SERVICE BULLETIN

Rudder Centering Fork - Control Stop Replacement

SB-ASTM-CTLS-02

Fig. 1

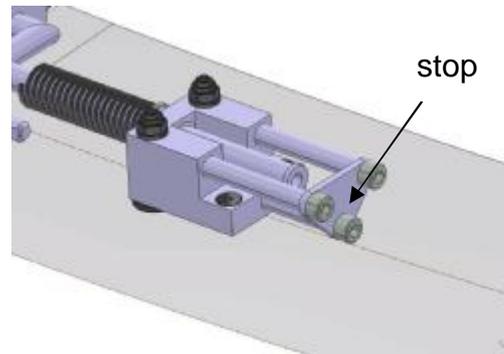
This is the rudder stop system that was installed to the CTLS affected by this SB ex factory. In this system the stop is provided to the rear end of the rudder centering fork, installed to the tunnel, below the instrument board. See following Fig. 1 and Fig. 2 for illustration.

This system is the system affected by this SB.

Fig. 3

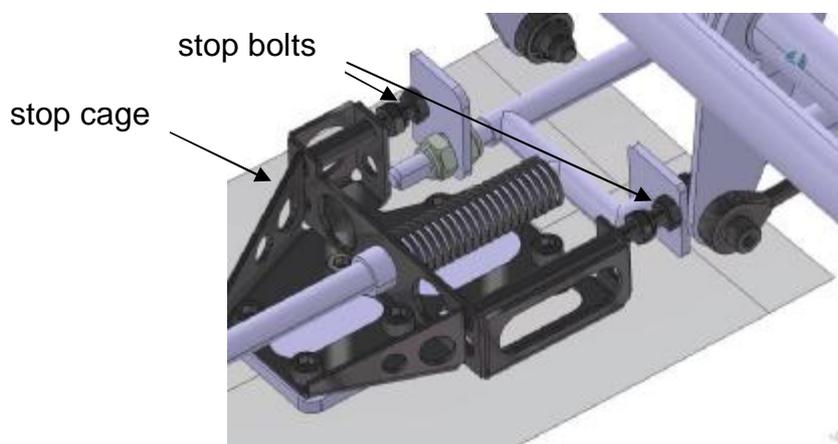
The new fork stop system provides a stop not to the rear end of the rudder centering fork, but to the thrust plates where the rudder centering fork contacts the bolt heads from the rudder pedal levers. The variant is clearly recognizable by the steel welded cage that provides the stops by means of adjustable bolts. See following Fig. 3 for illustration.

This stop device represents the valid type design and is used in serial production at the time of issuing of this SB. Only on aircrafts where the Rudder Stop Plates as by 3.1.3 cannot be used, this new fork stop system must be installed following SB [2].

Fig. 4

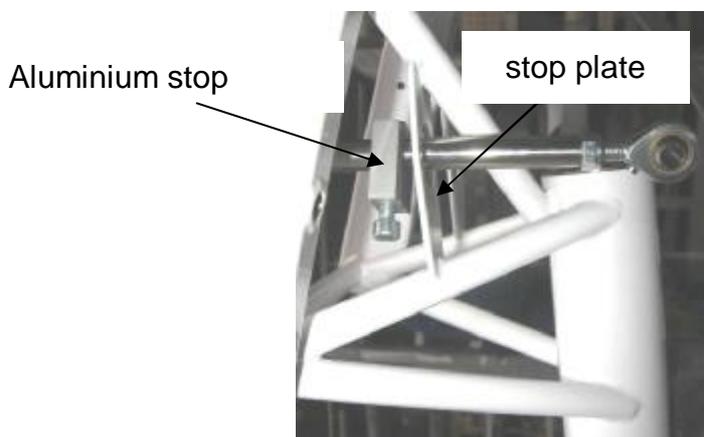
The rudder stop plates provide rudder stop not at the rudder centering fork. Aluminium stops, positioned to the control rods that connect the pedals with the nose gear steering, come to a stop against two stop plates welded to the big engine mount, in front of the firewall. See following Fig. 4 for illustration (only partially installed situation).

This stop device represents the valid type design previous to the introduction of the old fork stop system. It has been replaced in production due to the more complex adjustment principle, coupling with the rudder control rope pretension. On aircrafts where the welded stop plates are still available, this previous stop system shall be used again as it is easier and faster to be installed. The modification procedure is provided by this SB.

Fig. 5

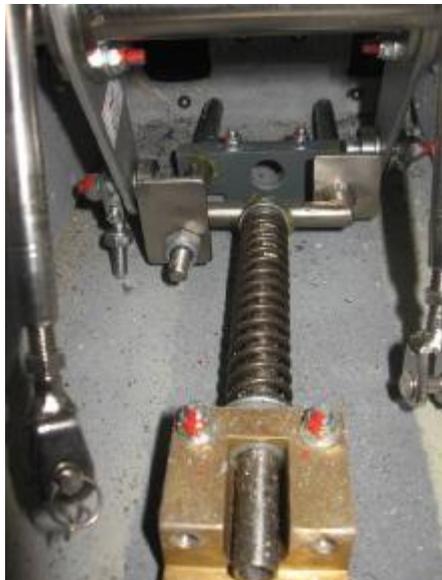
1. The rudder centering fork is not deformed, fork tubes are straight, and fork plates (small square plates shown on the fork, Fig. 5) are not bent or deformed. The correct configuration is shown on Fig. 5, 6;

When deformation is detected at the rudder centering fork, this fork must be exchanged.

Fig. 11

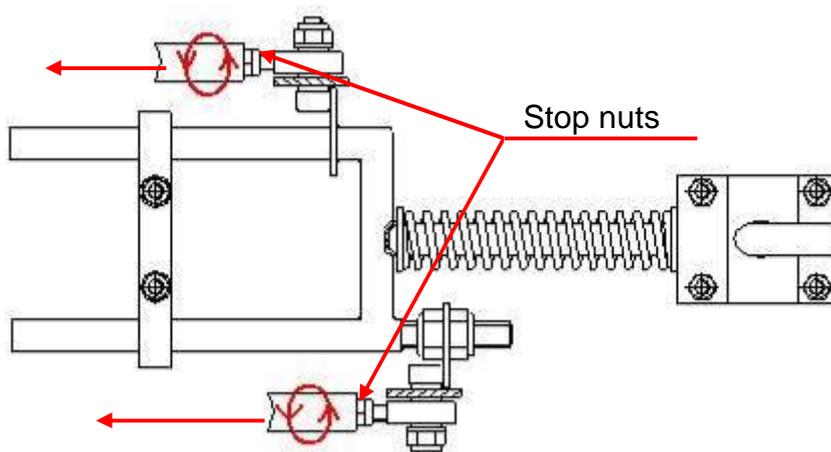
Unscrew pushrods from the cockpit side in the tunnel (Fig. 11). To loosen pushrods, hold self-locking stop nut on the rod end bearing with a suitable wrench. Do not change the position of the self-locking stop nut on the rod end as this will be the adjustment guide for the re-installation later.

Insert the pushrods back through the dust covers in the firewall. Thread the pushrods back to the stop nuts of the rod end bearings (that were left in position, see Fig. 11) on the cabin side of the firewall. After threading the pushrod back on, the rod end bearings on the engine side of the firewall must be aligned vertically, so that they match the nose wheel steering again. Tighten the stop nuts (Fig. 11) in this correct position.

Fig. 13

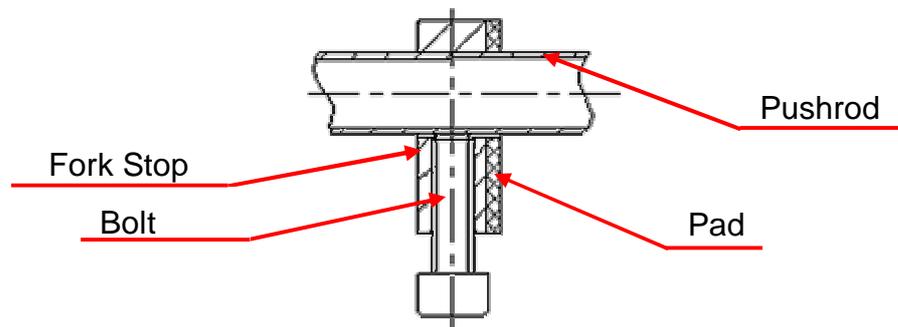
Loosely thread in the two (2) DIN 912 M6x20 bolts into the Aluminium stops, but do not tighten them yet before re-installation and adjustment (Fig. 13).

Fig. 14

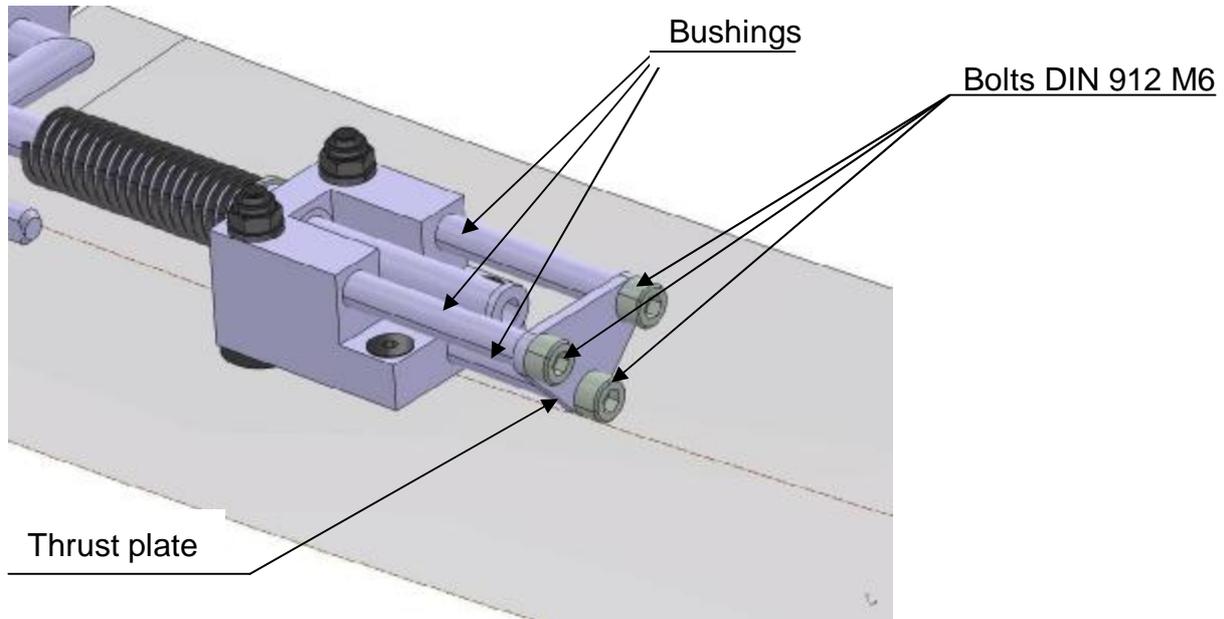
The old fork stop system, that guides the rear end of the rudder centering fork, must be uninstalled when the rudder stop plates are installed. To do this, remove the three bushings, bolts and thrust plate shown in Fig. 14 from the fork mount block. Unscrew three (3) DIN 912 M6 bolts (Fig. 14). Discard these parts.

Fig. 15

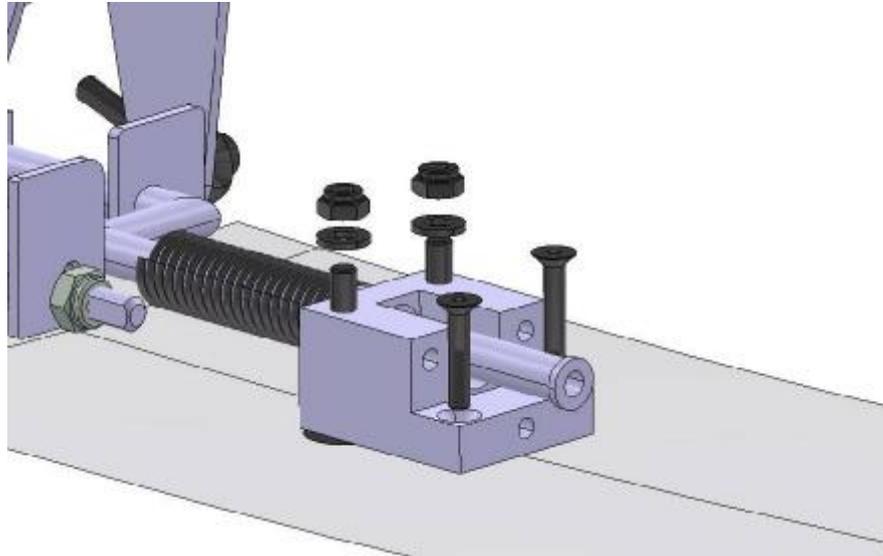
Remove the rear aluminum fork mount block from the lower fuselage skin by unscrewing the 4 bolts as shown in Fig. 15.

Make certain the position of the left side fork plate (Fig. 5 and Fig. 15, above, left side) is adjusted to the same position as on the original fork.

Re-attach the aluminium fork mount block with the same 4 bolts. Replace the self locking nuts with new parts. Apply tightening torque: 5.5 Nm.

Fig. 16

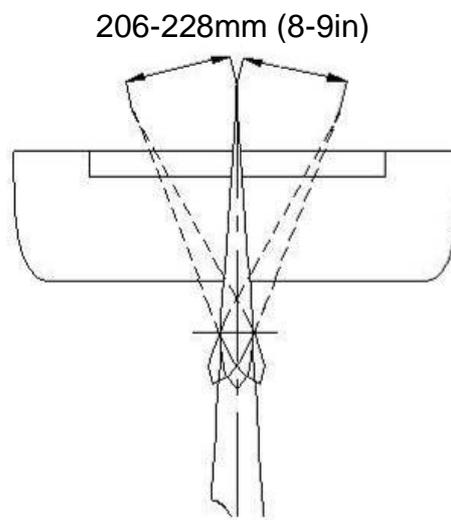
Maximum rudder deflection is measured at the lower trailing edge of the rudder as shown in Fig 16.

Move the position of the Fork Stop Plates as necessary to achieve the correct rudder deflection. When correct deflection is confirmed, tighten the two (2) M6 bolts on the stops to 4 Nm.
